**CONTRACT DOCUMENTS & TECHNICAL SPECIFICATIONS  
ADDENDUM NO. 2**

**Auburn Heights Preserve  
Paper Mill Bridge  
Contract No. 2015-NVF-100**

Project Name: Auburn Heights Preserve  
Paper Mill Bridge

Date of Issue: August 10, 2017

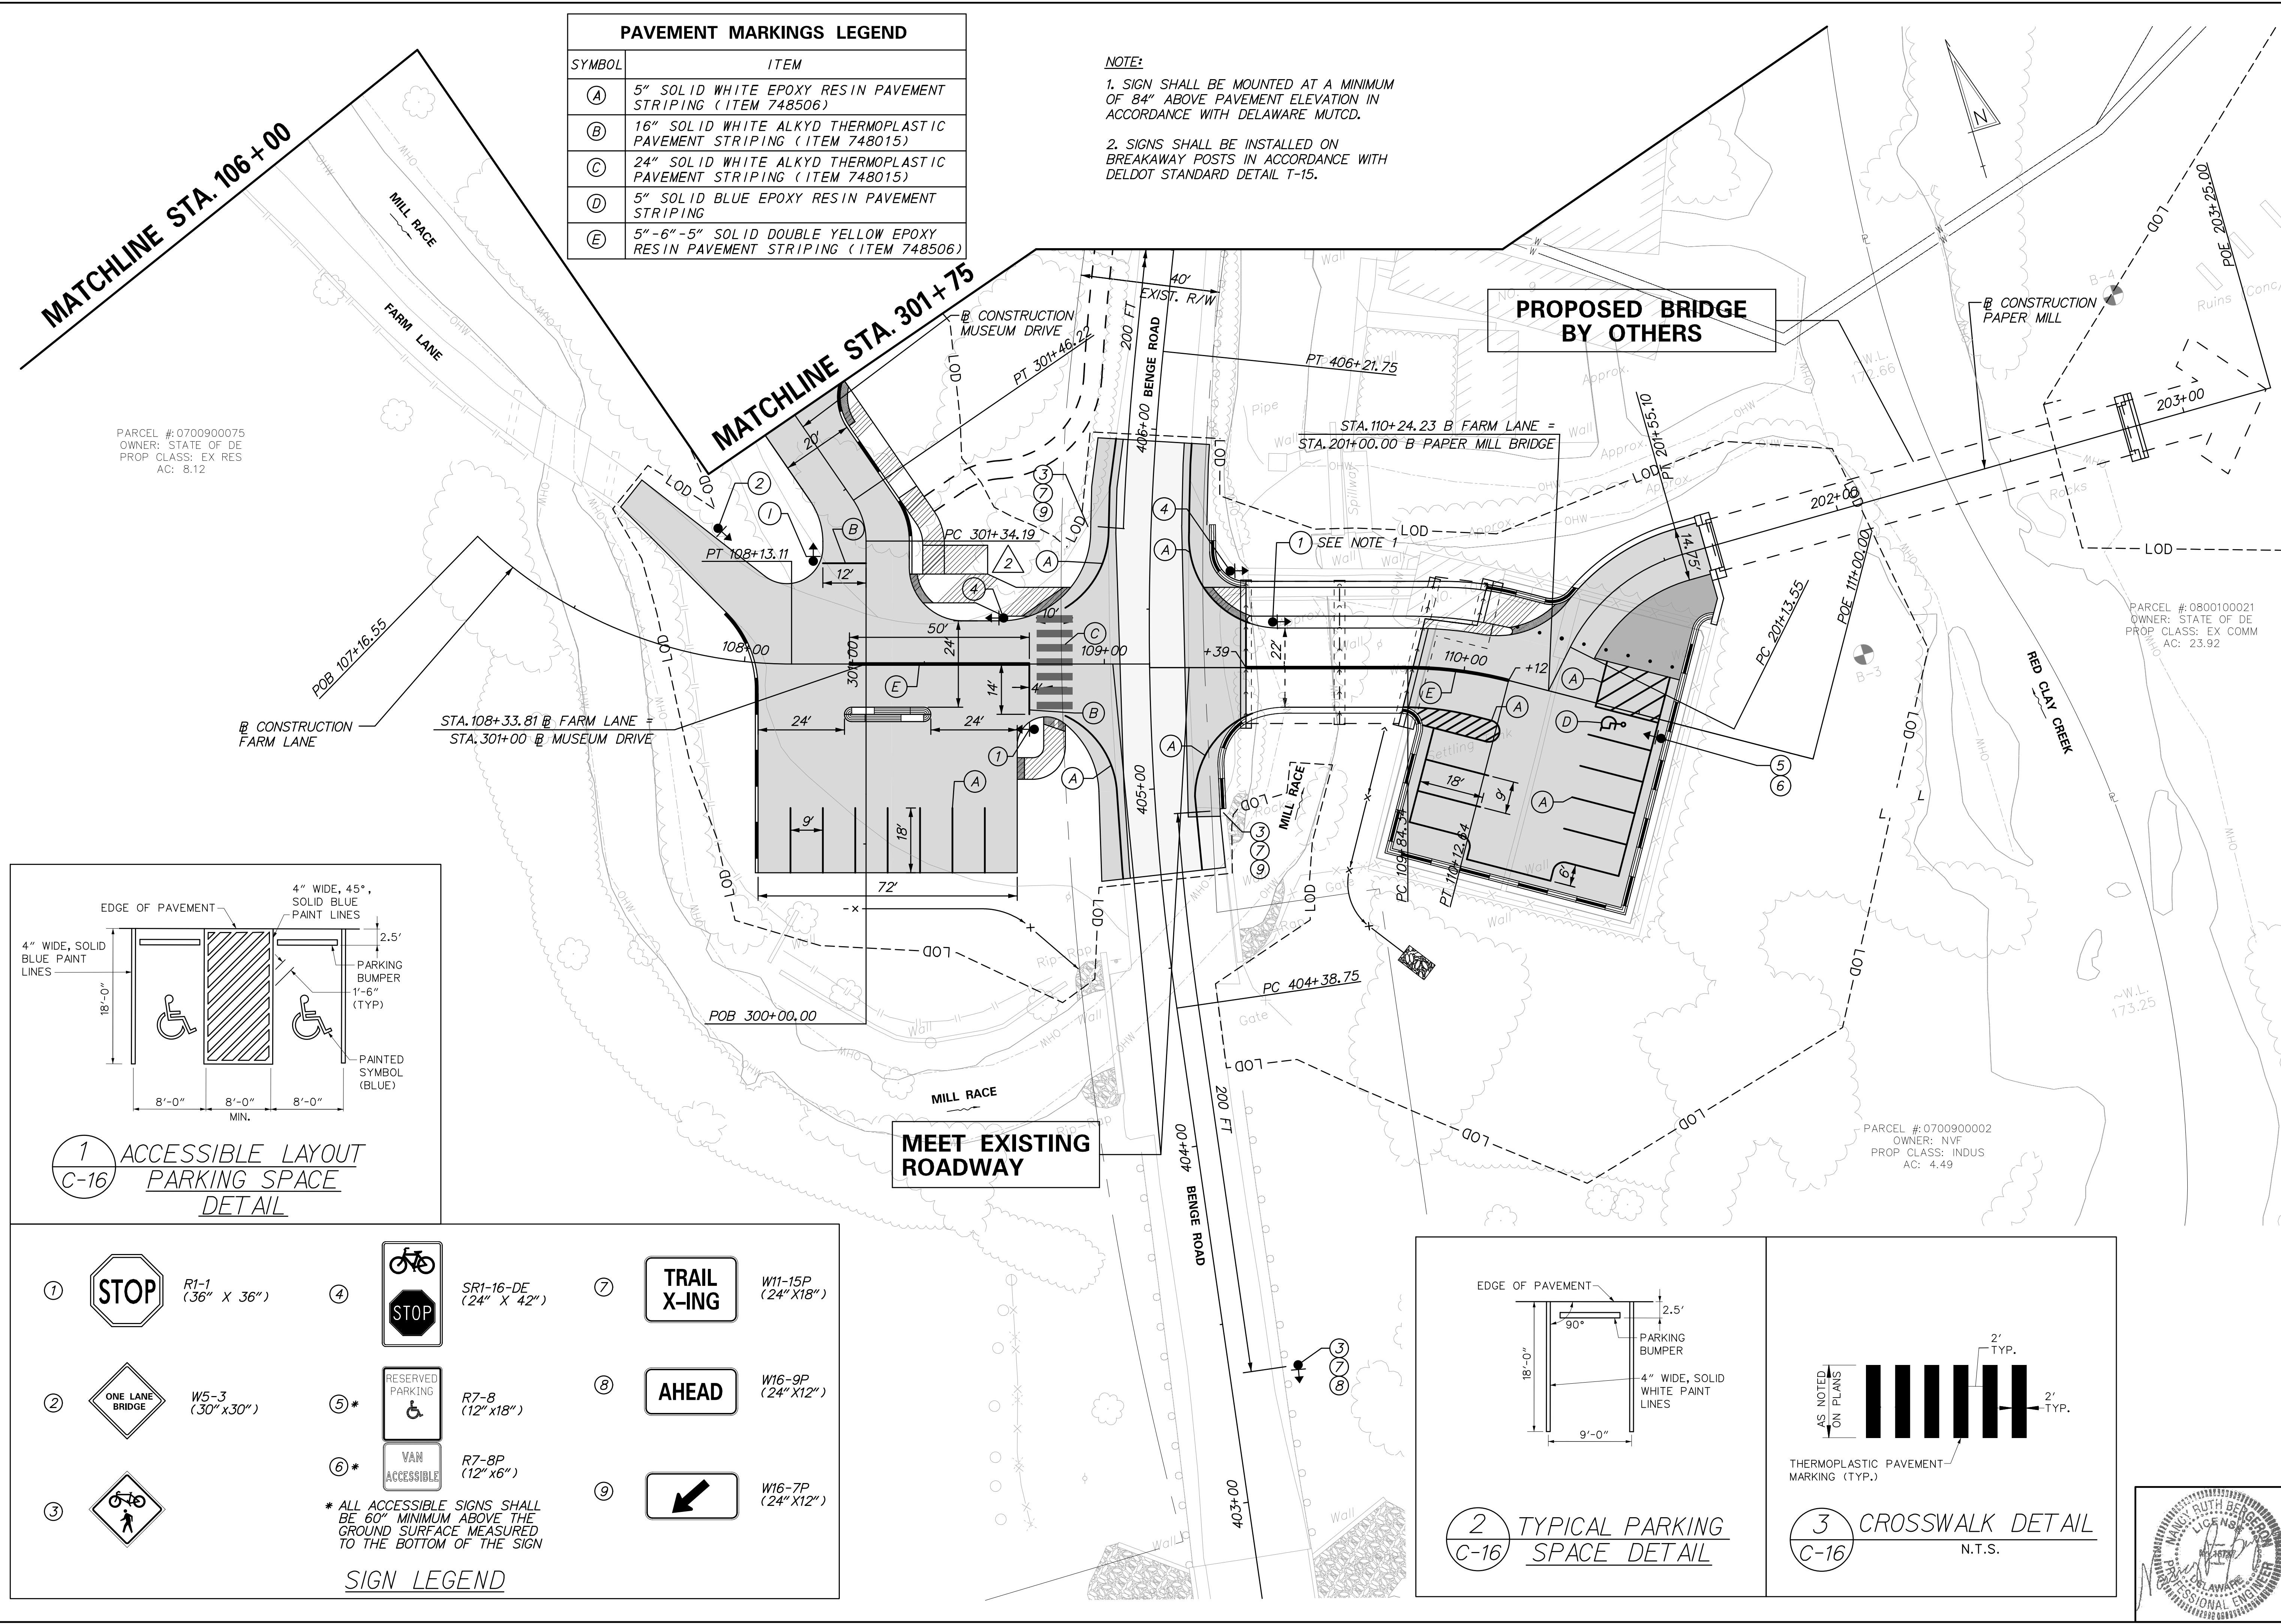
2. Demo Plan Sheet C-11 calls out notes 3 & 5, there is no note 5.

18. Plan Sheet C-11 Note 2 talks about intake and discharge pipes in the settlement tank being plugged, do you know how many of each there are and the size of intakes and discharges?

**Response: Sheet C-11, the call out referencing notes 3 and 5 has been revised and the revised sheet is included in this Addendum.**

**Response: It is assumed that 1-6" intake and 1-6" discharge pipe exist in the tank, and shall be included in the base bid. If additional pipes are encountered they shall be removed and plugged, as directed by the Owner. Cost for this additional work shall be documented and be paid under a Change Order.**
